Portland General Electric Company  
Trojan Nuclear Plant  
71760 Columbia River Hwy.  
Rainier, Oregon 97048  
(503) 556-3713

CPY-035-96

Response to Request for Additional Information

On August 20, 1996, Mr. Adam Bless sent a Request for Additional Information to Trojan that contained questions about License Change Application 237 (LCA-237), which requests permission to load spent fuel casks in the Trojan Fuel Building. The responses to the questions are provided in Attachment I of this letter.

Cask Movement Envelope - "Safe Load Path"

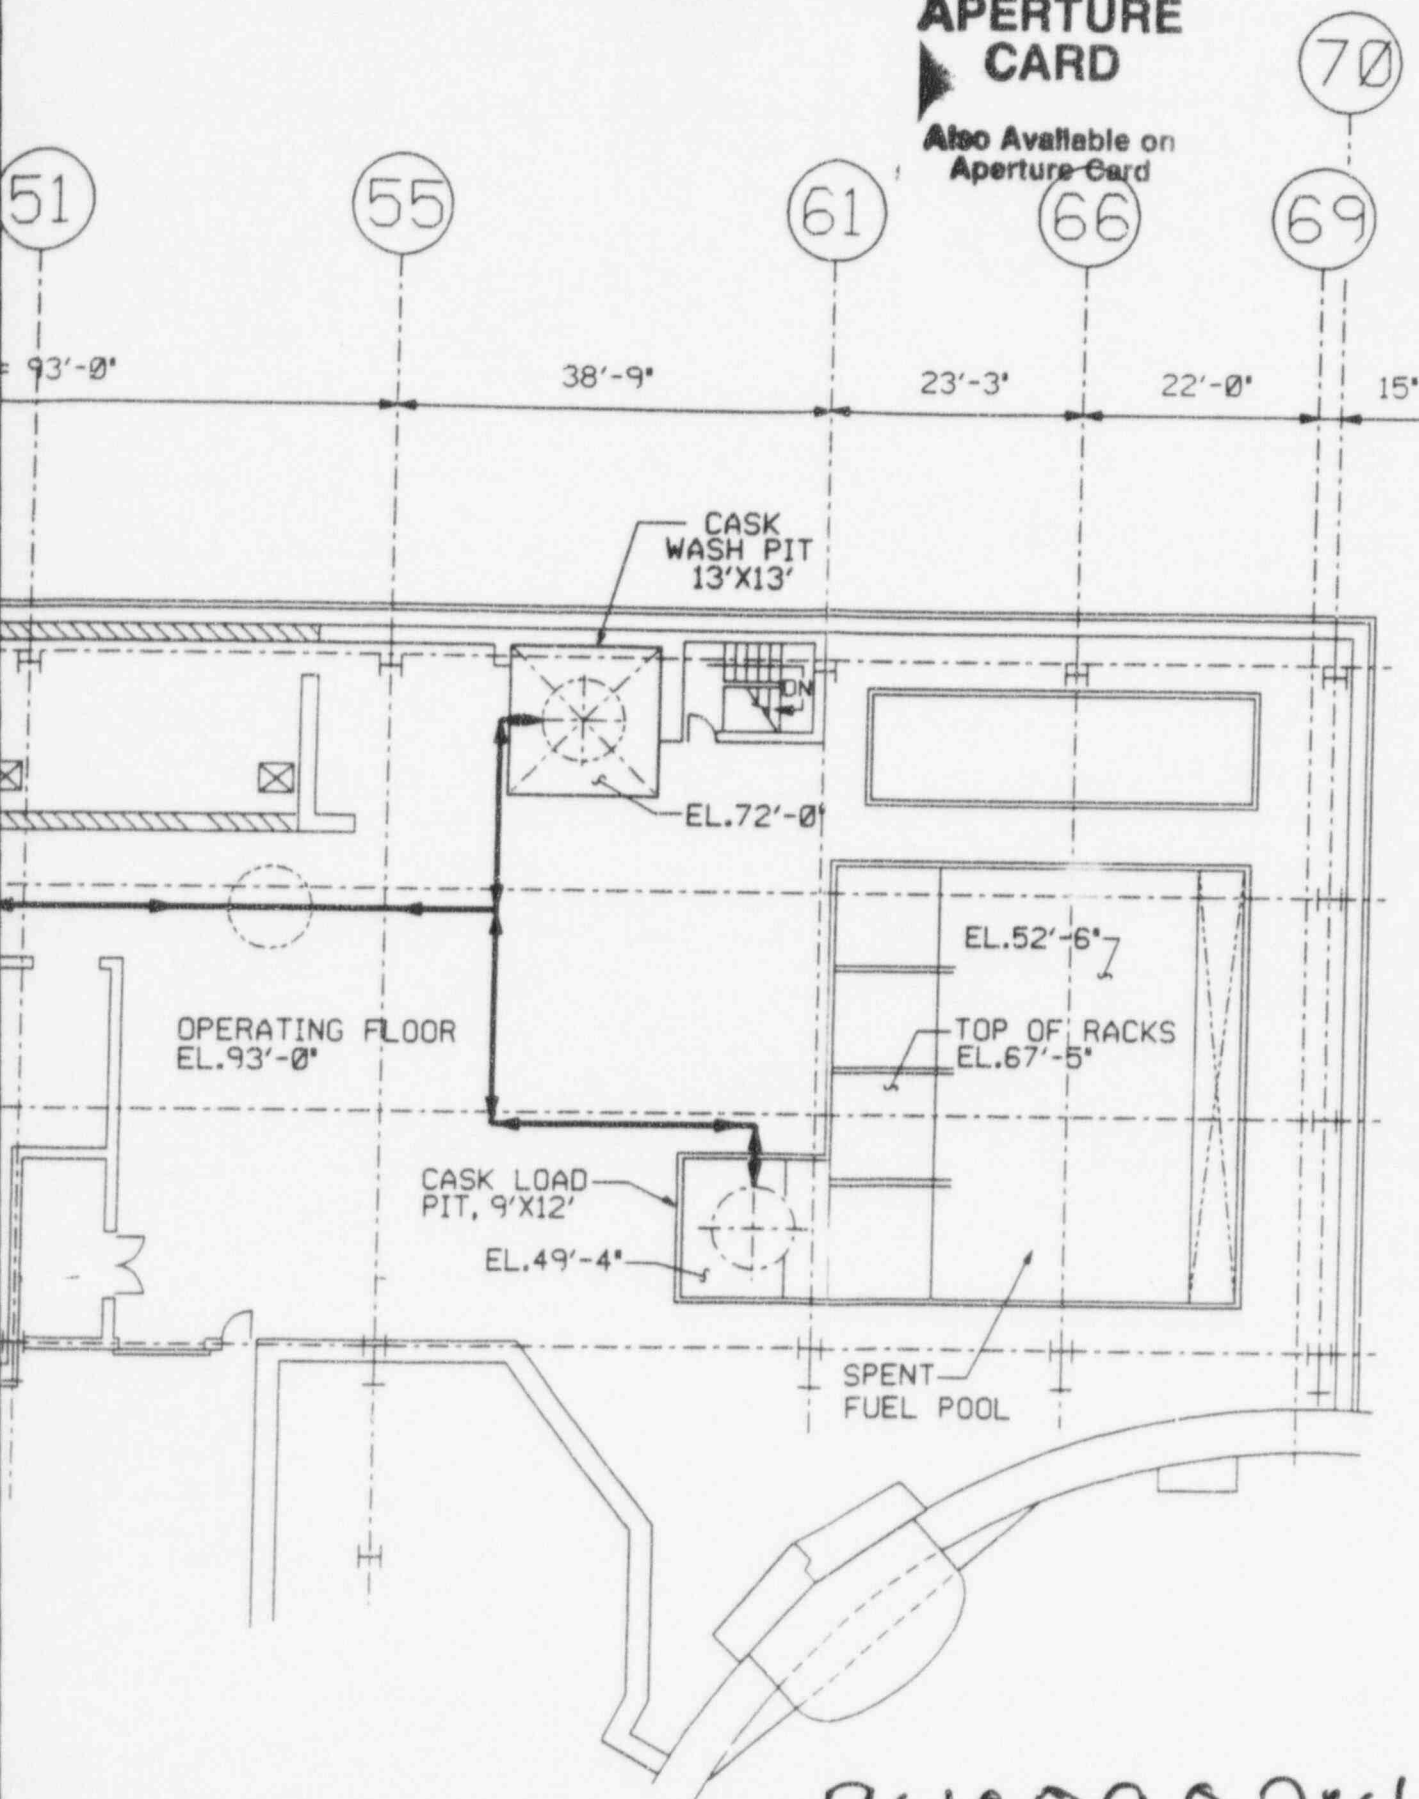
Regarding the crane operator training specified in NUREG-0612, how soon prior to load movement will it occur? Does this training adhere to the guidelines in ANSI B30.2-1976? Will the training include movement along the "safe load path"? Will the "safe load path" be defined in procedure and clearly marked on the floor? Please provide a diagram of the safe load path.

Crane operators at Trojan are given training that complies with ASME B30.2. Initial training is provided prior to being qualified to operate the equipment with requalification training required annually. In addition, specifics of crane operation for heavy load handling for ISFSI will be included in prejob briefings and in the preoperational setup and testing phase. Safe load paths for ISFSI will be incorporated in Trojan Procedure TPP 14-9 prior to ISFSI load handling. Safe load paths will be marked on the floor where feasible and diagrams will be placed in the crane operators cab. Sacrificial floor coverings (herculite or equivalent) may be placed on the floor between the Cask Loading Pit and Cask Wash Pit to contain drips from the SFP and rinse down. The floor coverings may cover the floor markings. However, the load path will be designated on those coverings to the extent feasible.

A copy of the safe load path is provided as Attachment II.
